## Product Change Notice (PCN)

**PCN Number:** PCN-0451399R-01

Product(s) Affected: *PJ-063AH & PJ-063BH*

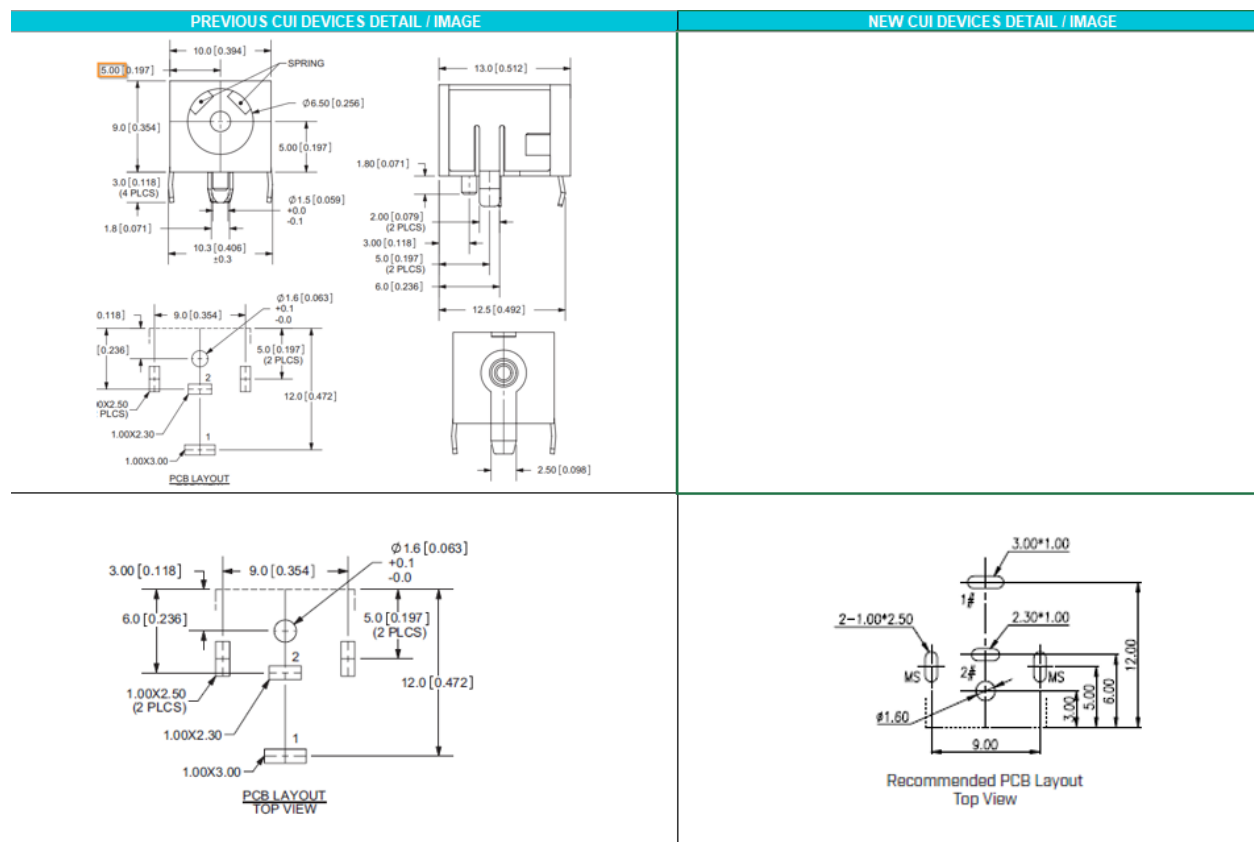
Description of Change: *Mold Change. Cosmetic differences on the mold. Stamping removed ("P" & "Made in China") All measured dimensions on the 2D drawing remain the same.*

MATING PLUG  
Jack Insertion Depth: 8.85 mm

MATING PLUG  
Jack Insertion Depth: 8.30 mm
